# Access Compliance Report

## Public Rights-of-Way

### (Curb Ramps)

Intersection ID: 16419	Main Street: LANTANA_AV	Cross Street: N_SHARON_AMITY_RD	Location: W
ADA ID: BDE116C0ABCE	Ramp Type: ParaDiag	Initial Pass/Fail: Fail	Overall Compliance: No
Severity Score: 13.75			
Codes/Mitigation Info/Possible Solution		Field Measurements/Component Compliance

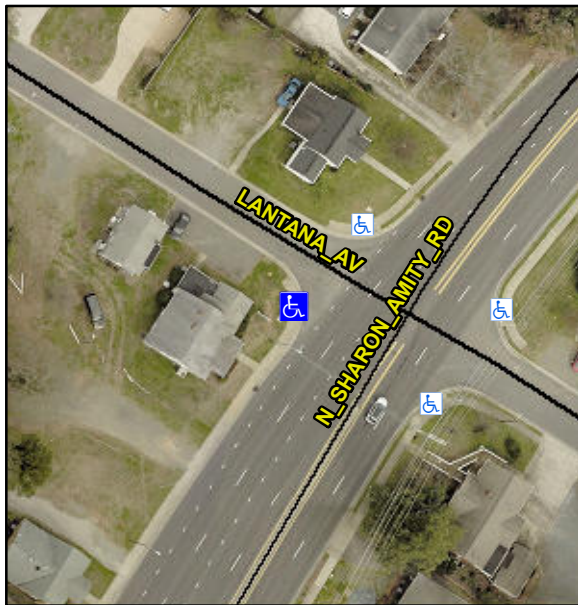
Surveyor Notes:

**LT RP < 5%**

PROW/ADA:

**R304.5.3, R304.3.2**

Possible Solutions:

**Remove & Replace Curb Ramp With Two New Directional Ramps or Equivalent.**
